Rationale for the proposed amendments to Regulation No. 110 (CNG/LNG vehicles)

Proposal - Alignment with ISO 11439:2013 - Proposed Revisions to:

Regulation No. 110

Craig Webster, P.Eng.
Convener – ISO TC 58/SC 3/WG 17 for the ISO 11439 Standard

Figure H.1 - Cylinder orientation and layout of exposure areas

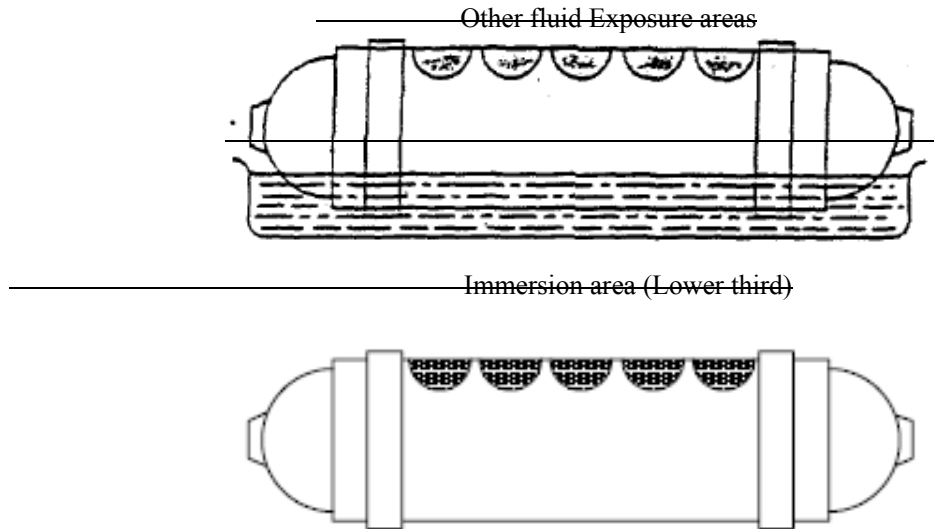
The immersion part of the test was eliminated in ISO 11439 as the concentrated exposures to the 5 chemicals would provide a more severe test condition.

The upper section will be divided into 5 distinct areas and marked for preconditioning and fluid exposure (see **Figure H.1**). The areas will be nominally 100 mm in diameter. The areas shall not overlap on the cylinder surface. While convenient for testing, the areas need not be oriented along a single line, but shall not overlap the immersed section of the cylinder.

Although preconditioning and fluid exposure is performed on the cylindrical section of the cylinder, all of the cylinder, including the domed sections, should be as resistant to the exposure environments as are the exposed areas.

Figure H.2

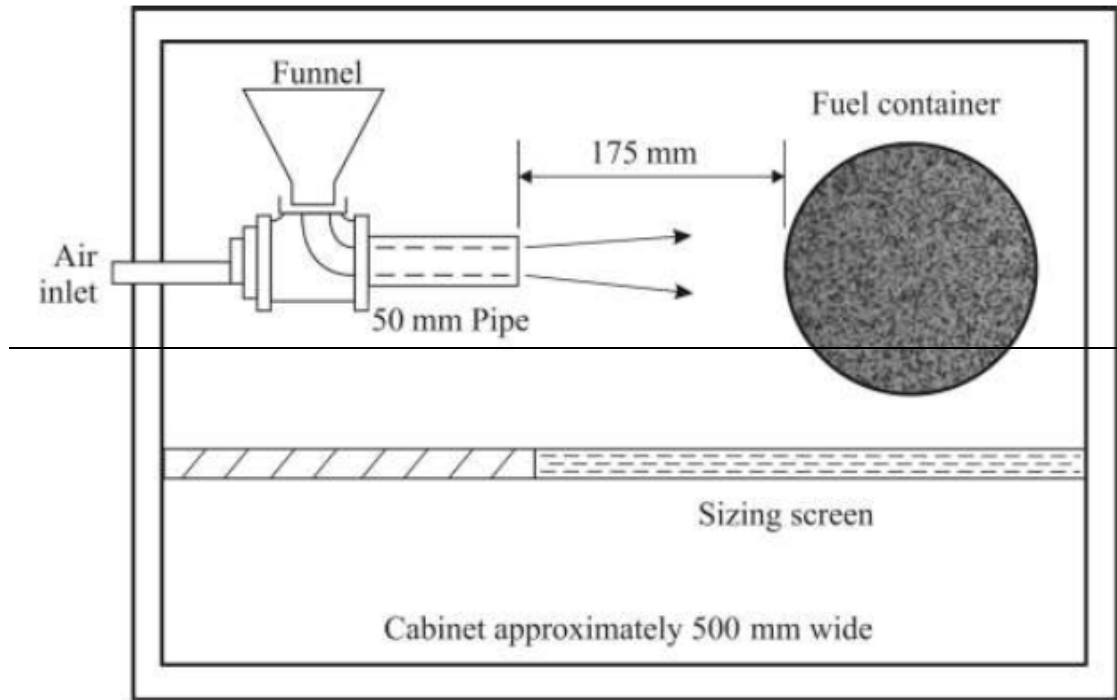
~~Machine constructed according to the design specifications shown in Figure H.2. This procedure for operation of the equipment shall follow that described in ASTM D3170, Standard Test Method for Chip Resistance of Coatings with the exception that the cylinder may be at ambient temperature during gravel impact;~~

~~Alluvial road gravel passing through a 16 mm space screen but retained on a 9.5 mm space screen. Each application is to consist of 550 ml of graded gravel (approximately 250 to 300 stones);~~

It was found in testing that the gravel impact had no apparent effect on the integrity of cylinders, or any protective coating – the pendulum impact was a much more severe test of a coating.
